Re: French River Sewage Treatment Lagoon Capacity
EBRO File Number: 10EBR006.R

Thank you for agreeing to our request to undertake a review of the Certificate of Approval No. 9346-7SLKMD for the Noëlville sewage treatment lagoons in the Municipality of French River. You have requested further clarification from us, which is provided herein.

Figure 1 - 392 m³/day

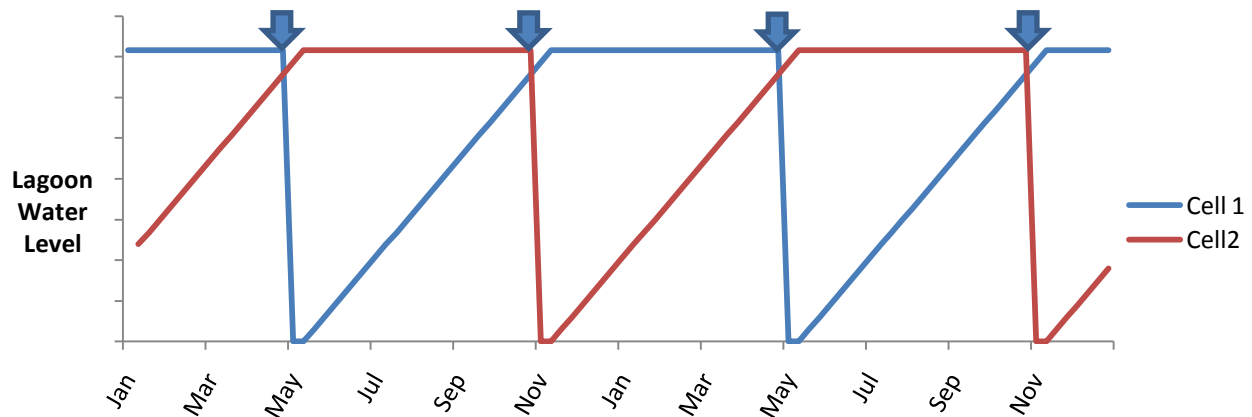
1-At 392 m³/day the lagoons each fill once a year, as depicted in Figure 1. The horizontal portion(s) of the lines are the retention period(s) when sewage is held in the lagoons for treatment. The blue arrows represent the semi-annual, spring and fall seasonal discharge events.

Figure 2 - 784m³/day, seasonal discharge

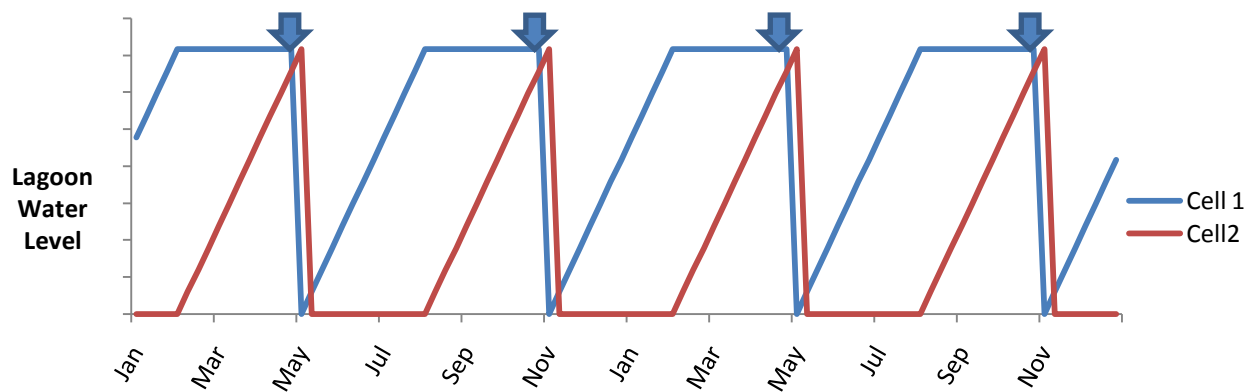
2-At 784m³/day the contents of each cell are release twice a year (Figure 2). The contents of Cell 1 are held for about 75 days before discharge but the sewage in Cell 2 must be discharged with minimal retention time of a few days in order to meet the seasonal discharge schedule. If Cell 2 was held for 75 days as Cell 1 was filling before being discharged, then discharges would occur in February, when the receiving waters are frozen over, or in August, when water levels are at their lowest and the receiving water is barely flowing, if at all. Neither of these discharge times provides the adequate flow to incorporate the effluent into the environment. Note that on the seasonal discharge schedule Cell 2 sits empty and unused for half of the year.

Figure 3 - 477 m³/day, late discharge

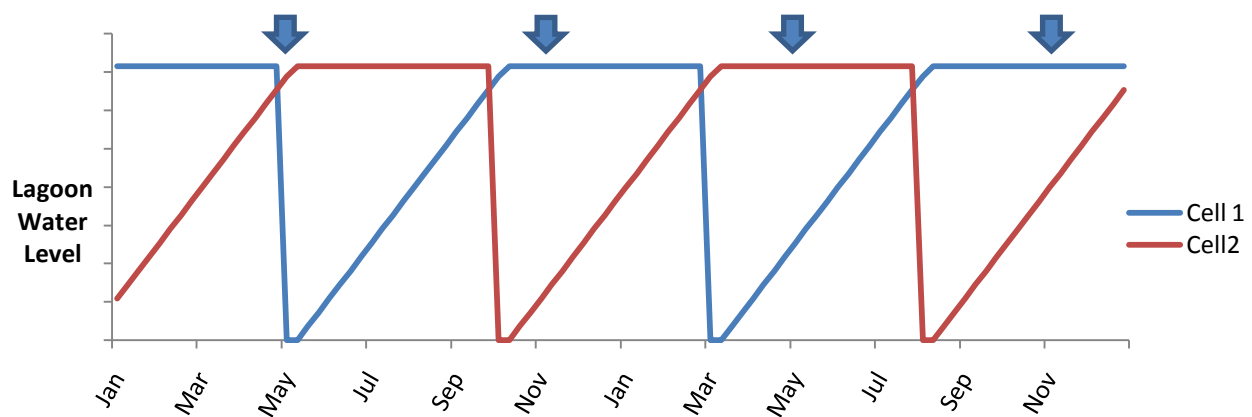
3-At the current rated capacity of 477m³/day the lagoons cannot meet their performance criteria as specified in the Certificate of Approval. That is because at 477m³/day the lagoons would fill in 300 days and for 65 days of the year there would be nowhere for the raw sewage to go. If the cells were discharged just in time to receive more sewage on a 300 day schedule as depicted in Figure 3, then discharges would occur in the summer and winter seasons with the problems noted above. At this rate of one discharge every 5 months, there would be 12 discharges over a 5 year period, with one discharge in each calendar month.
